COMMUNITY DEVELOPMENT

DEPARTMENT REPORT

SUBJECT: [H-2023-0071](#)
District at Ten Mile – CPAM, MDA,
RZ, PP

LOCATION: Northwest corner of S. Ten Mile Rd. &
I-84 in Section 15, T.3N., R.1W.

Applicant Proposed:

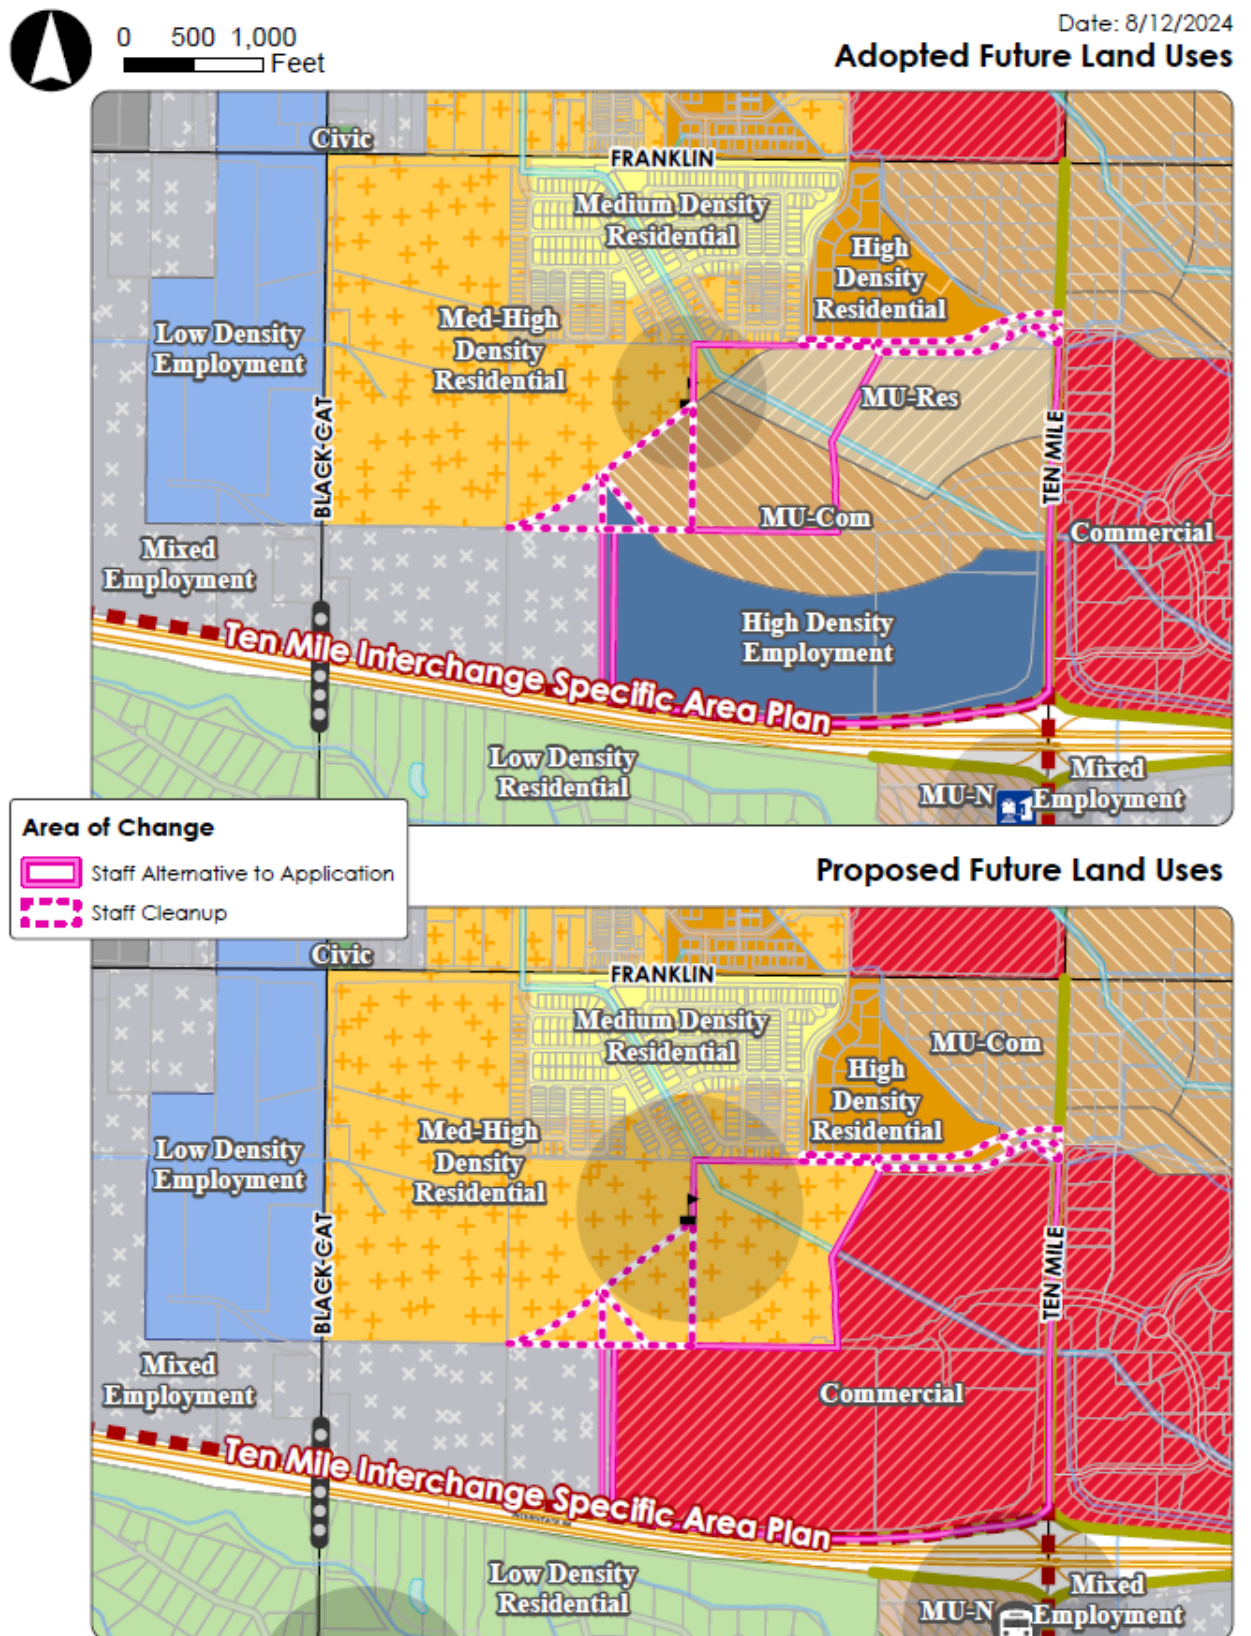
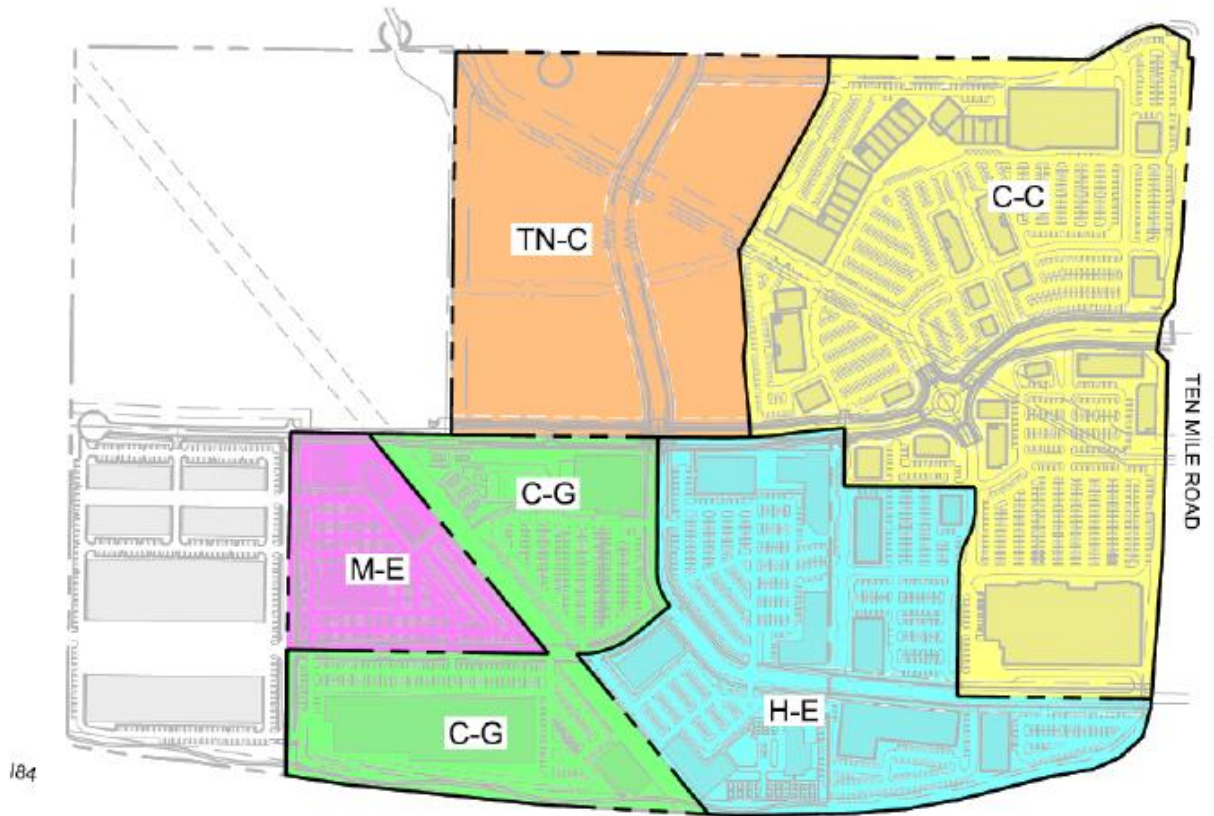
In summary, Staff is *not* in support of the proposed map amendment and associated rezone based on the conceptual development plan proposed as it doesn’t meet the *minimum* development guidelines in the TMISAP nor does it provide the mix of *integrated* uses desired in Mixed Use designated areas or the intensity and/or types of uses desired in the MU-Com and HDE designated areas.

If Council is of the opinion the proposed development plan is more appropriate for this area than that envisioned in the adopted TMISAP, Staff suggests alternate FLUM designations and zoning are approved consistent with the proposed development plan, as follows: MHDR and R-15 zoning for the property in Area 1; and Commercial and C-G zoning in Areas 2 and 3 (see second adopted vs. proposed FLUM exhibit in Section VII.C).

H. Use Area Plan

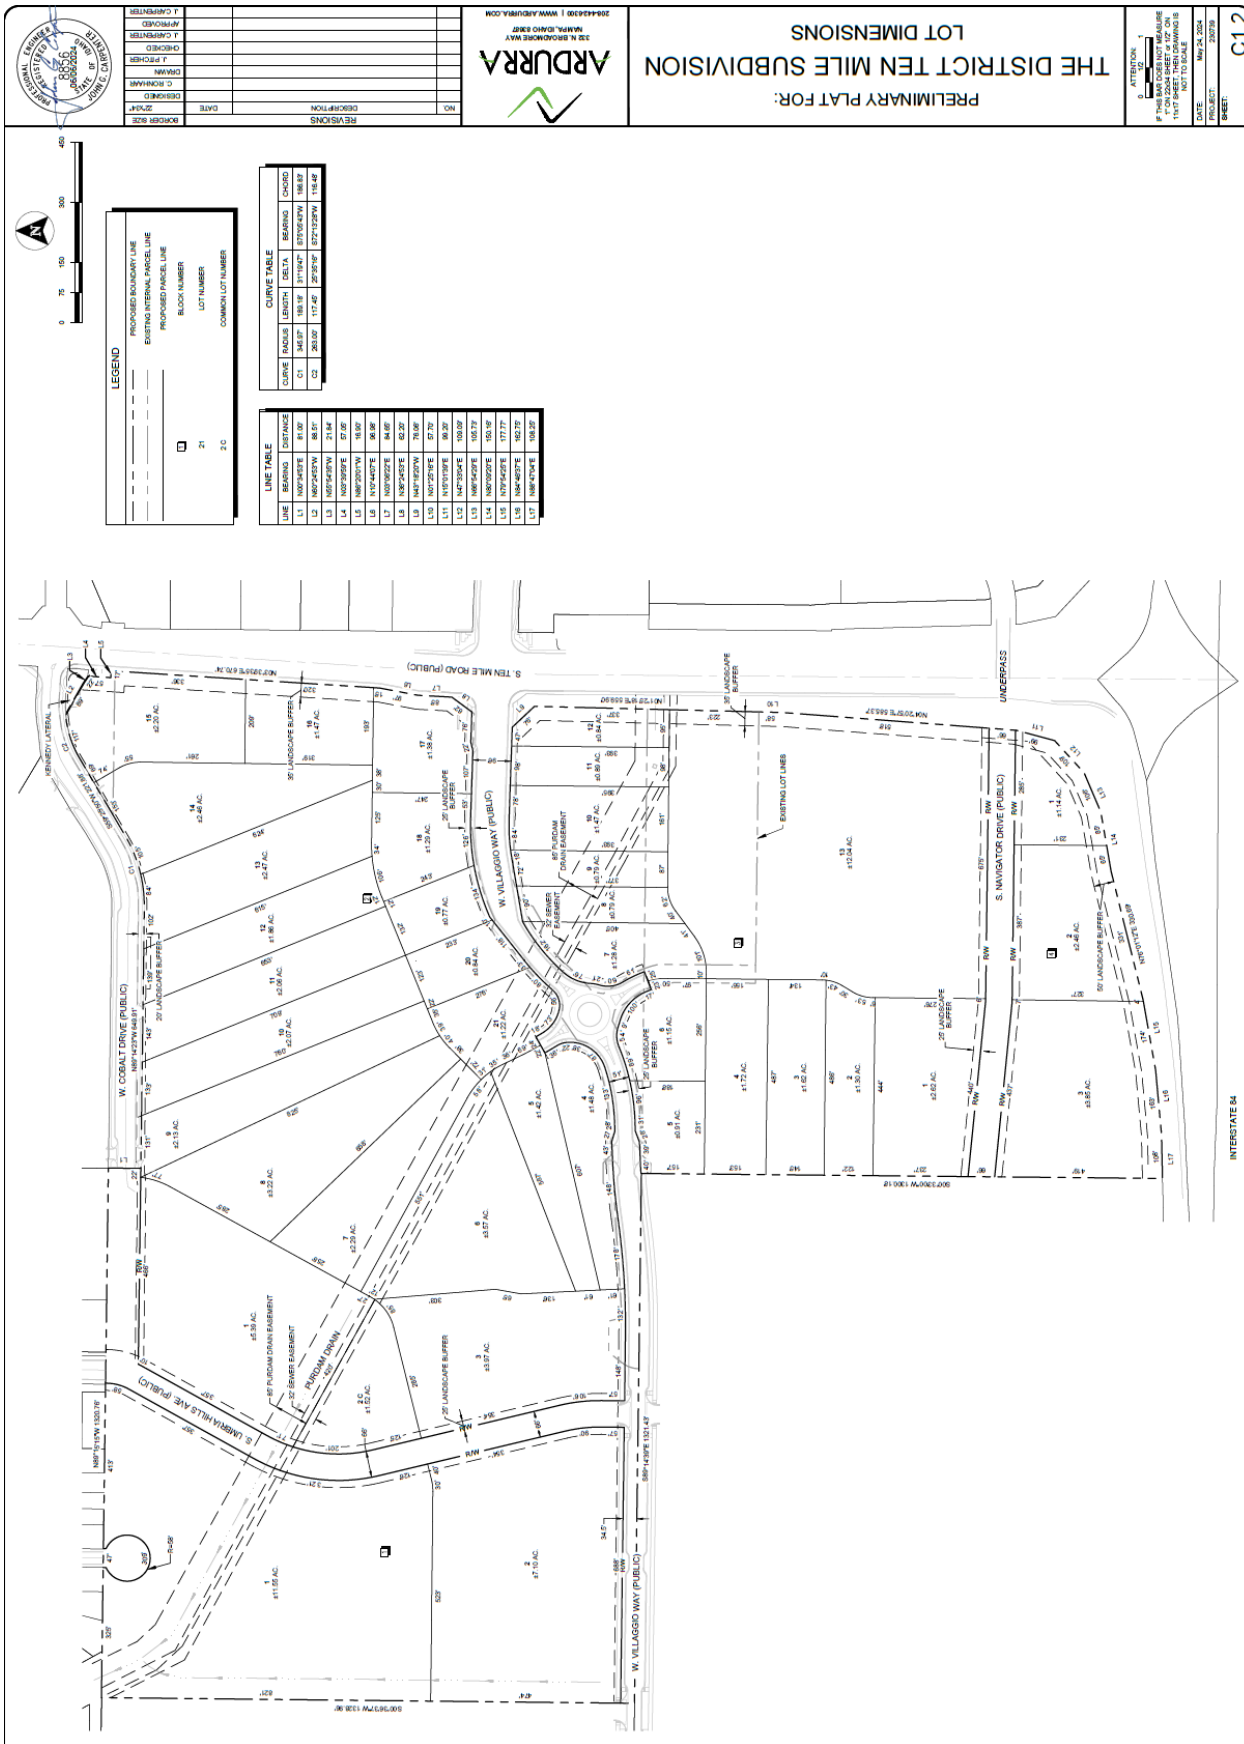
Only residential uses are proposed in the requested MU-Res FLUM designation and TN-C zoning district – the “mixed-use” component of the designation and TN-C district is *entirely* missing. Only one of the three major use categories are proposed (i.e. residential) – no retail, office or employment uses are proposed as required, which are essential in MU-Res designated areas. The proposed MU-Res designation and TN-C zoning is *not* consistent with the proposed development plan or the intended plan for this area as the required mix of *integrated* uses is not provided.

Although a mix of commercial uses are proposed, only one of the three major use categories is provided (i.e. commercial) – no major employment uses are proposed as required in either the MU-Com or the HDE areas and integrated residential uses are not proposed in the MU-Com area, which are essential. The proposed MU-Com and HDE designations are *not* consistent with the proposed development plan or the intended plan for this area as the required mix of uses is not provided – significant changes to the concept plan and use area plan would be needed in order to be consistent.

See above for information on MU-Com and HDE designated areas and associated analysis. **As noted above, the FAR’s in the MU-Com and HDE areas are *significantly* below the established goals in the Plan. Although commercial and employment uses are proposed from the three (3) major use categories, integration of residential uses is not proposed as desired. Office and other employment uses need to be of a much higher intensity in this area in order to be consistent with the MU-Com and especially the HDE designation and designed as compact urban centers rather than lower density suburban-style development Recreation uses are not desired in HDE designated areas.**

- ii. Future development of Area 1, as depicted on the Use Area Plan in Section VI.H, shall be consistent with the development guidelines of the Medium High Density Residential Future Land Use Map designation in the TMISAP.

- iii. Future development of Areas 2 and 3, as depicted on the Use Area Plan in Section VI.H, shall be consistent with the Commercial Future Land Use Map designation in the Comprehensive Plan.
